**AMMANA MARKET RENOVATION
MAJJASIM, IRAQ**

SUSTAINMENT ASSESSMENT

**SIGIR PA-09-171
JULY 30, 2009**

SUBJECT: Report on Sustainment Assessment of the Ammana Market Renovation, Majjasim, Iraq (SIGIR Project Number PA-09-171)

Figure 1. General site plan for the market

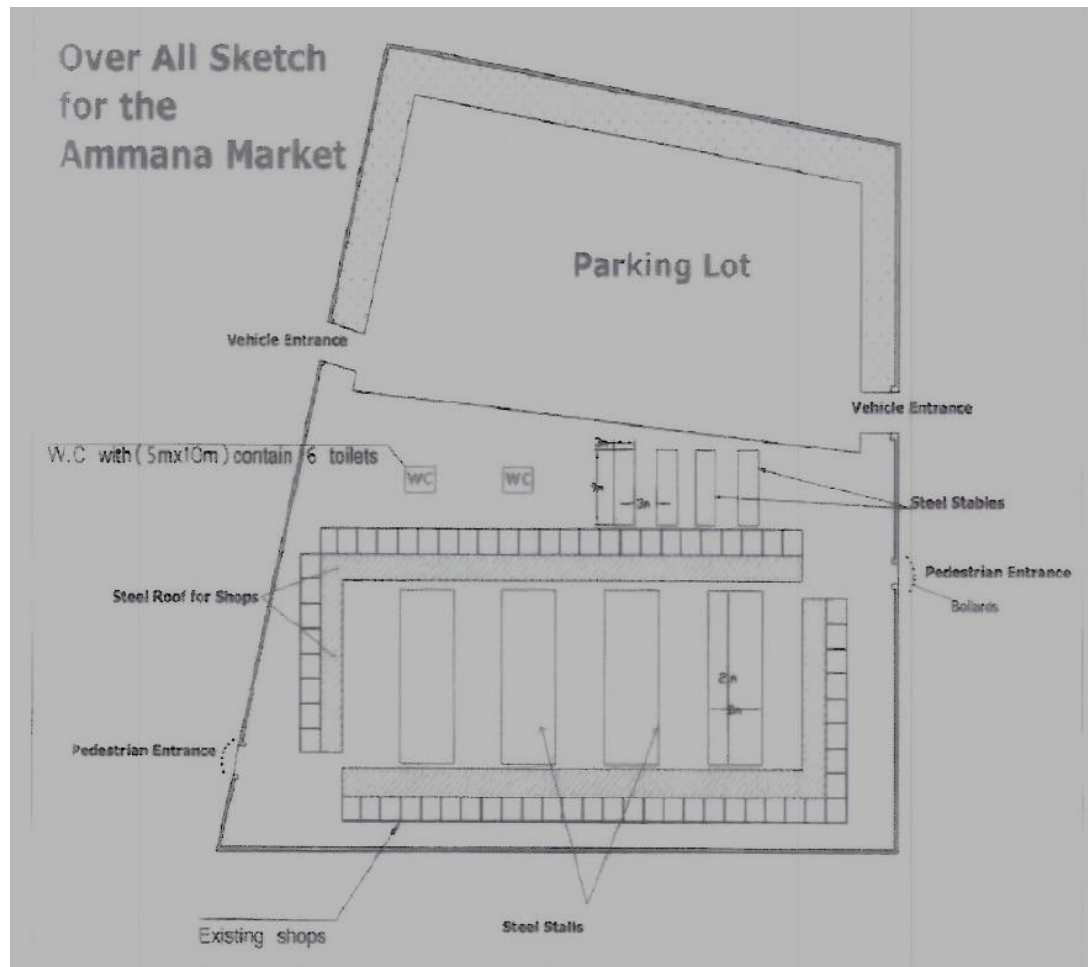
The contractor provided the project timeline with the contractor's proposal, which included the general site plan (Figure 1). However, MNC-I advised SIGIR that its project file did not contain the contractor's shop drawings, design calculations, or material lists.
